Staff Report July 31, 2018

RE: Village at Loomis Second Study Session

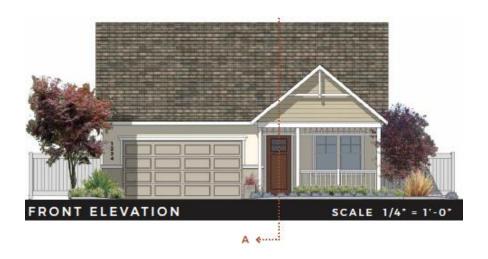
<u>Commission/Council Comments</u>: For the Village Traditional district, the Commission recommended a minimum lot size of 4,000 SF, 5-foot side setbacks, 20-foot rear setbacks for units adjacent to units on David Avenue and Silver Ranch Avenue, and 15-foot rear setbacks elsewhere. The Council requested a minimum lot size of 5,000 SF and setbacks similar to those discussed by the Commission.

<u>Proposed Project Modifications:</u> The Village Traditional district was redesigned to provide more active park area, as discussed below. The depth of lots adjacent to units on David and Silver Ranch Avenues was increased to 100 feet, which appears to be the same depth as the existing lots on David Avenue. Because Staff does not have a tentative map with lot dimensions, Staff cannot verify whether or not the 20 foot setback request was accommodated. One lot was eliminated.

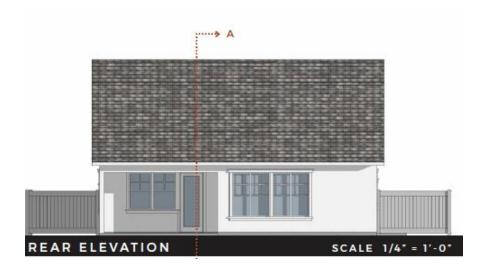
<u>Commission/Council Comments</u>: The Commission and Council heard concerns from residents on David Avenue and Silver Ranch Avenue regarding the potential interface between existing units and the height of units proposed in the Village Traditional district. To address residents' concerns, the Commission and Council directed that units on the north edge of the project (on the north side of Blue Anchor Drive) be restricted to single-story.

<u>Proposed Project Modifications:</u> On the north side of Blue Anchor Drive, adjacent to existing units on David Avenue and Silver Ranch Avenue, the applicant proposes a combination of single-story units (50%) and pop-up units (50%). The applicant contends that a pop-up unit does not have rear-facing, second-story elements (e.g., windows, dormers) and protects the privacy of existing residents similar to single-story design. A pop-up unit plan includes a second-floor living space in either a front-facing design (e.g., the home appears as a two-story home only from the front and a single-story home from the rear) or in the attic area of the home, with side-facing windows, as shown below.
